ADDENDUM #9

RE: Addendum #9
Electronic Access & Video Surveillance
Tyler Junior College
RFP #24-07

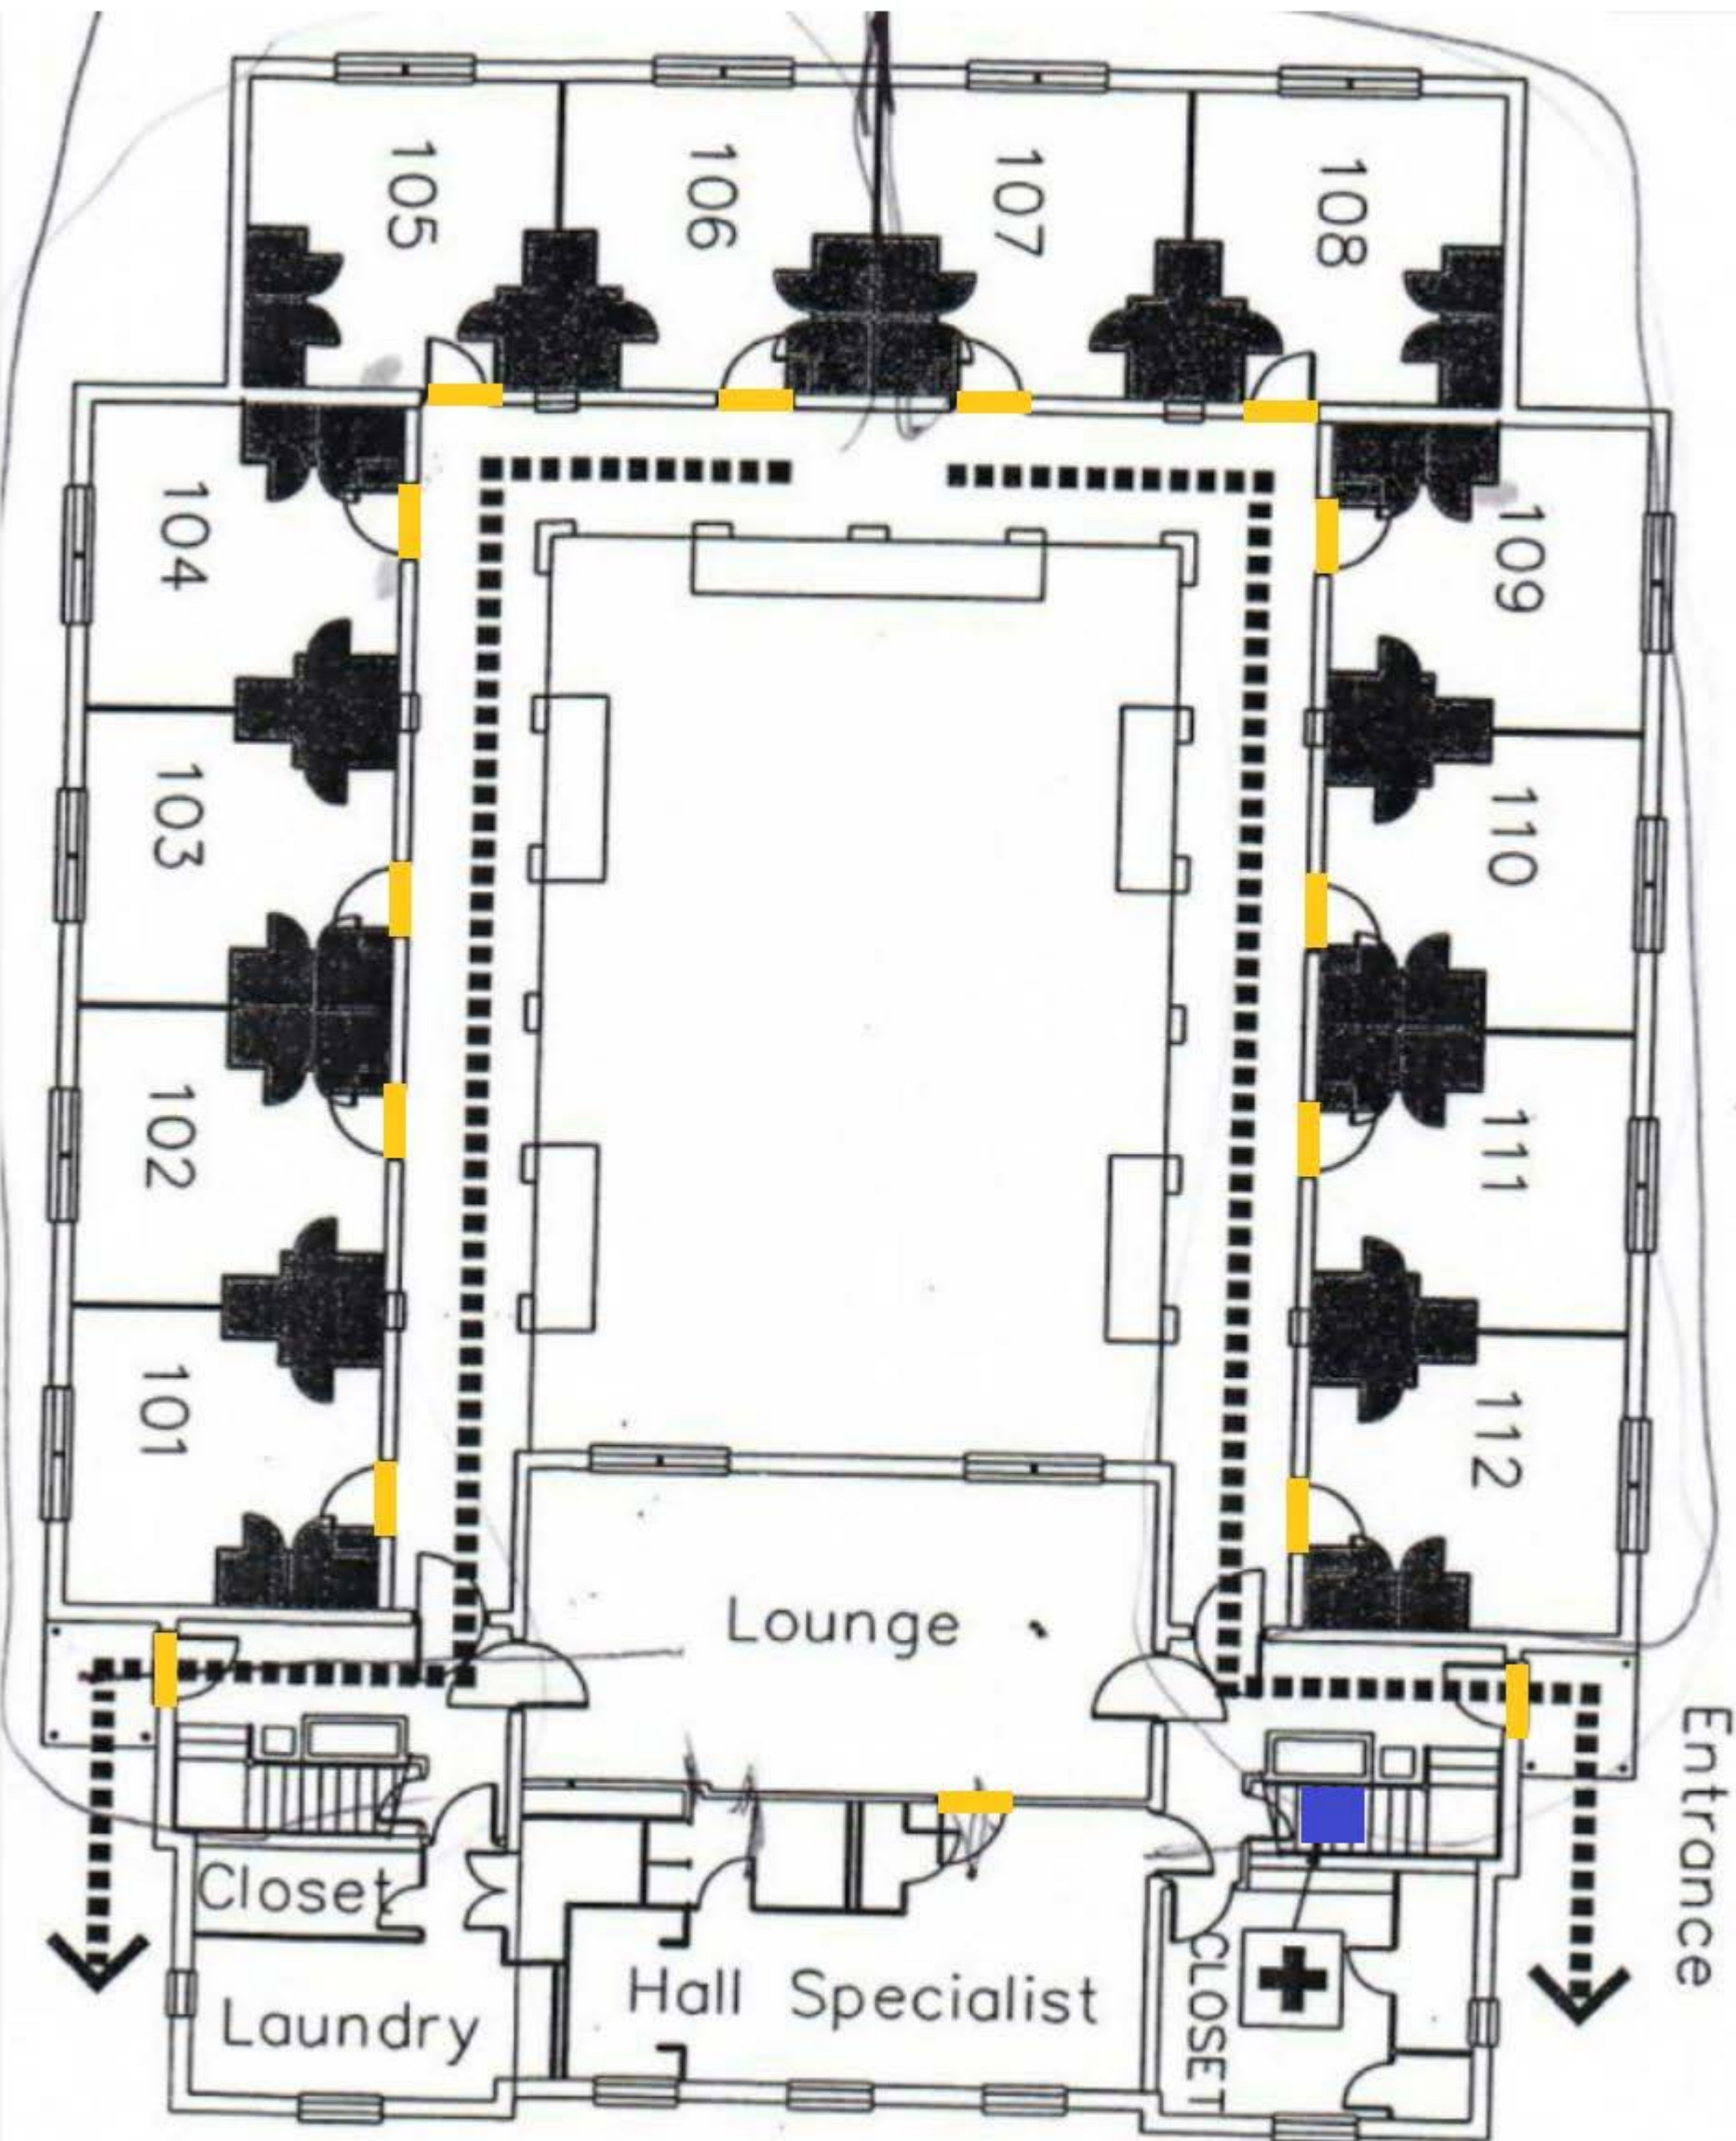
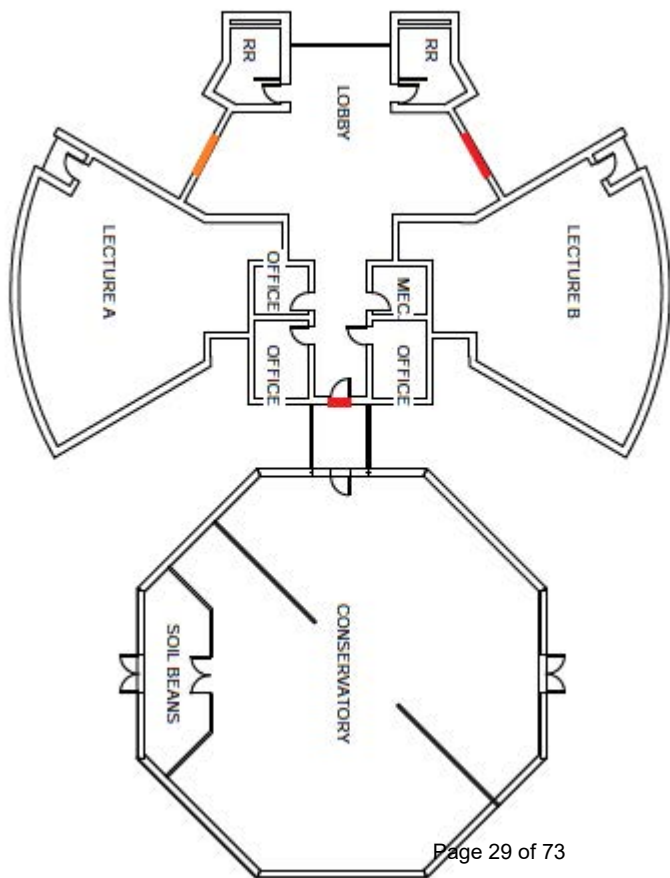
QUESTION #31: How many V1000 controllers are there currently?

ANSWER: 17 (see attached).

Lewis Hall - Second Floor

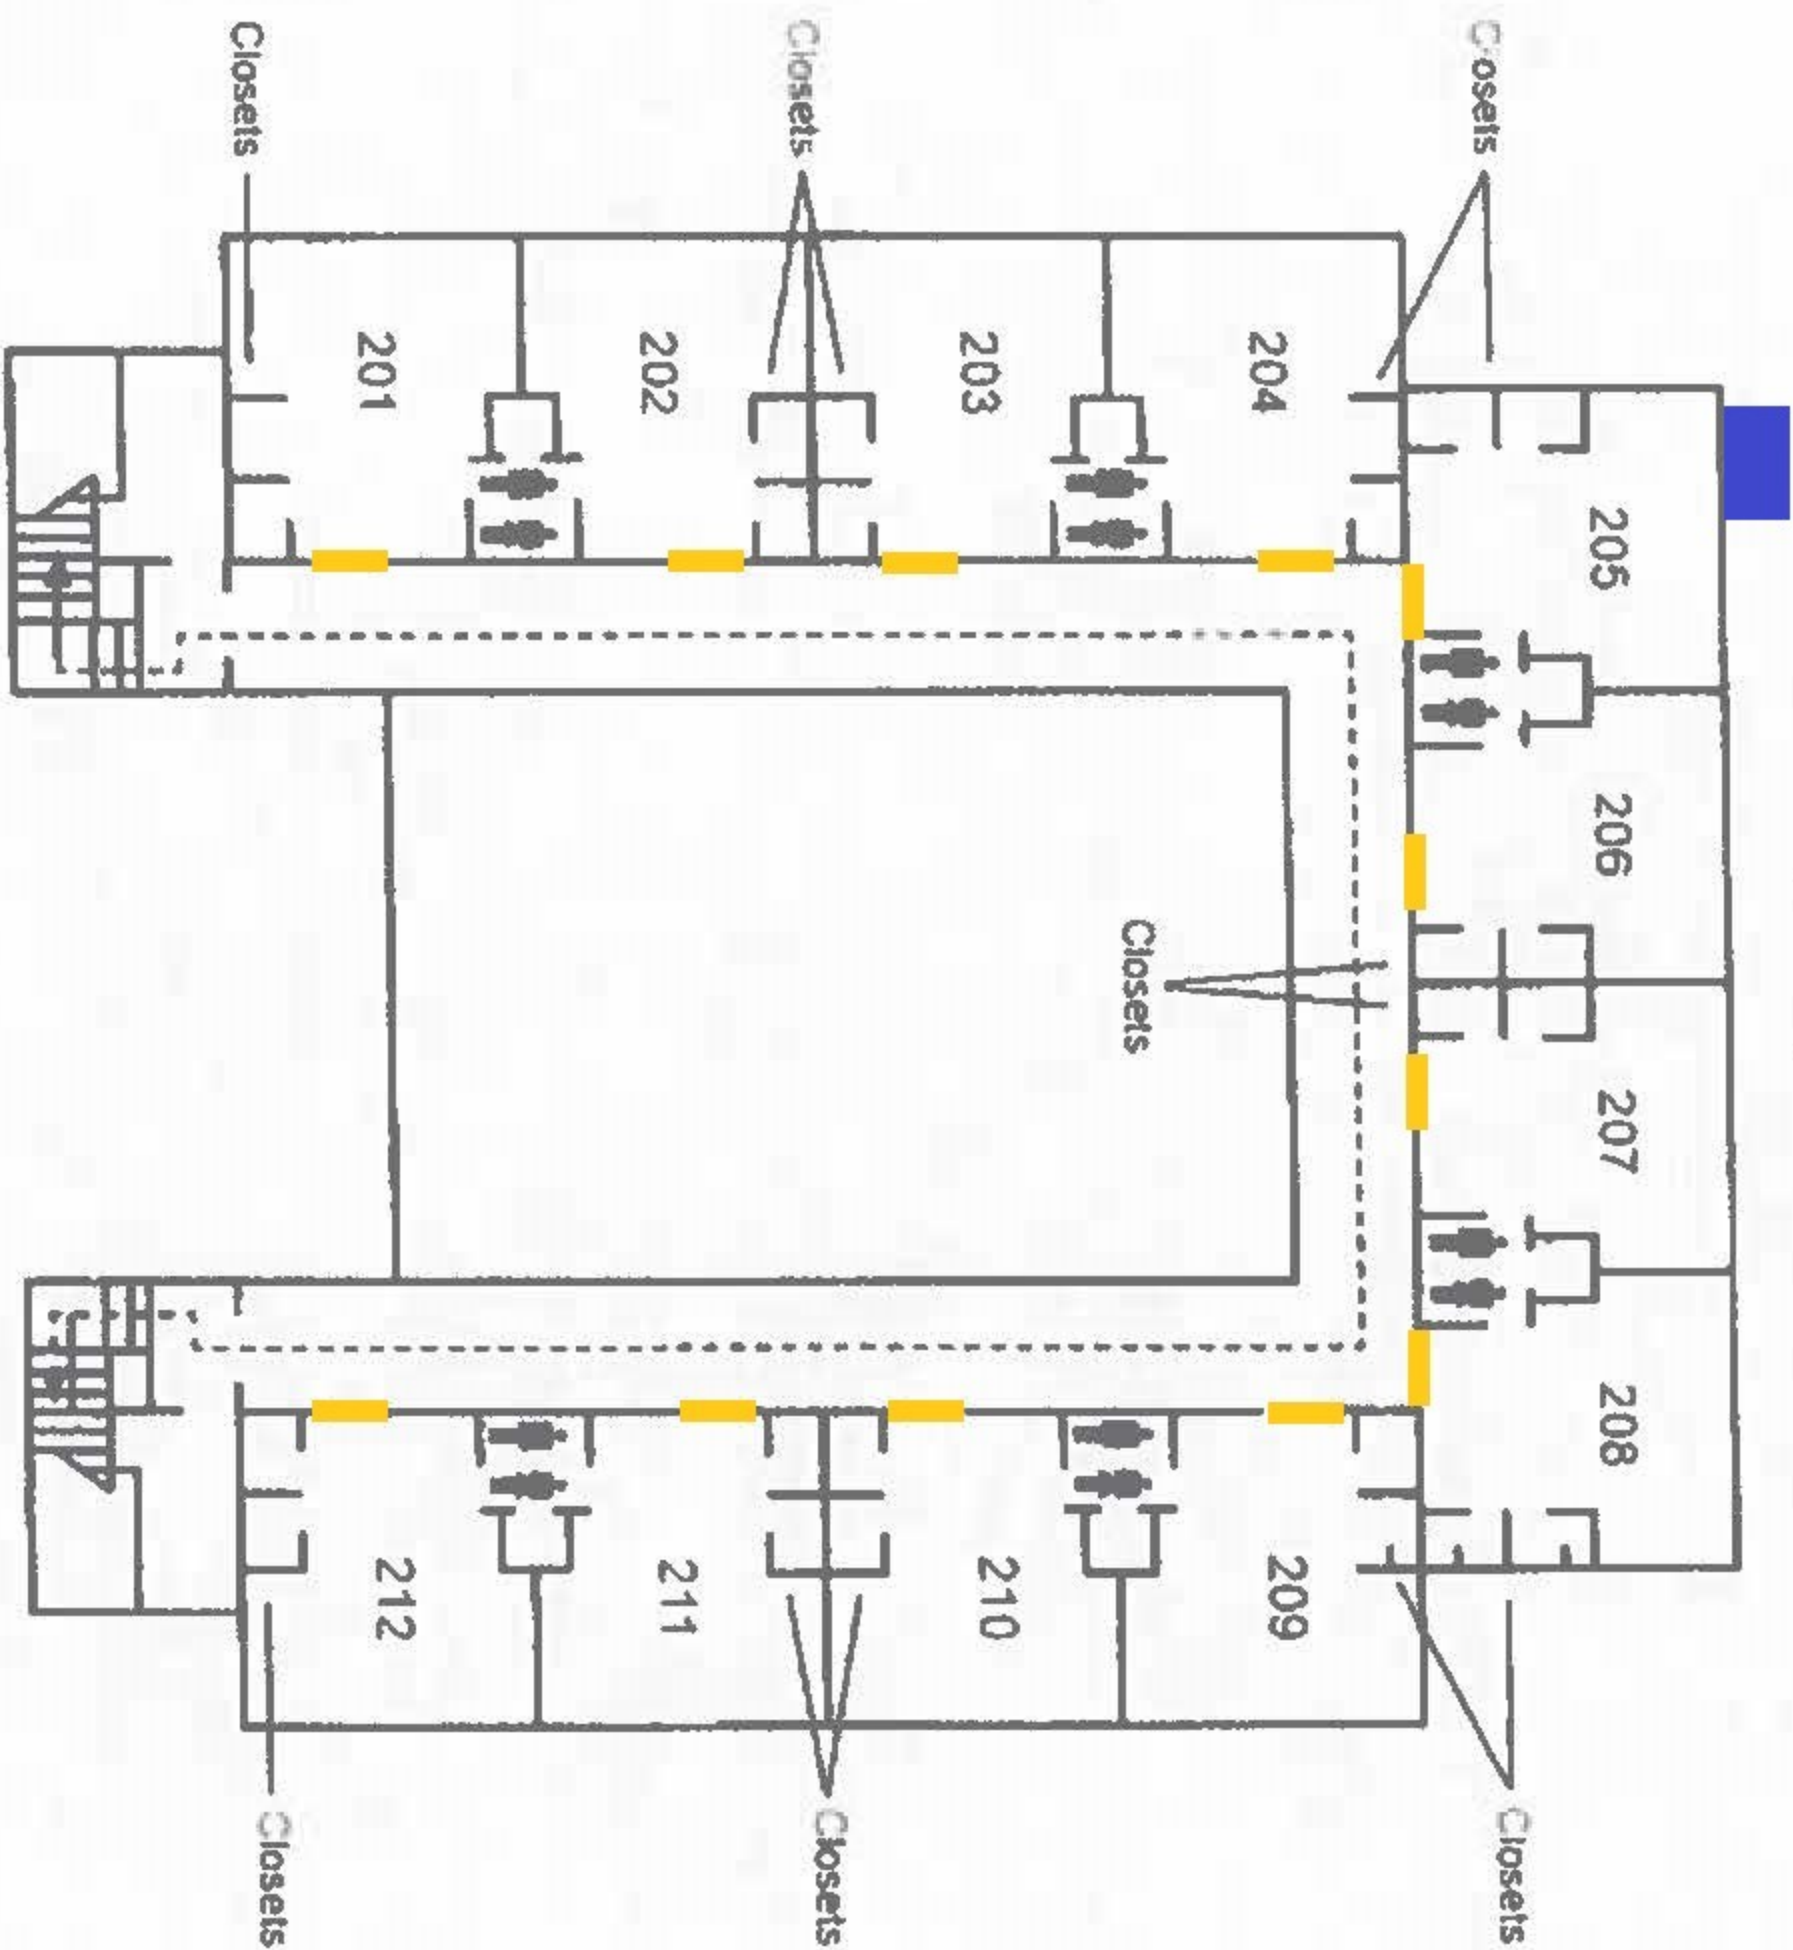
QUESTION #14: Addendum 5, Binder #1: Page 43 and 44 does not show an IT closet.

QUESTION #24: Noted that counts for Wesley House (Lewis and West) reflect the following:

1. Wesley House Lewis – drawing shows mark-up for 27 Onity locks, but addendum says 36.
2. Wesley House West – no mark-up on drawing to perform counts, but addendum says 27.
3. Are these numbers possibly flipped?
4. Will there be a marked-up Wesley Hall West drawing?

ANSWER: Attached an updated floor plan with the exterior IDF marked for Lewis and Wesley Hall.

ANSWER: There are 27 locks in Lewis and West. An updated map has been attached.
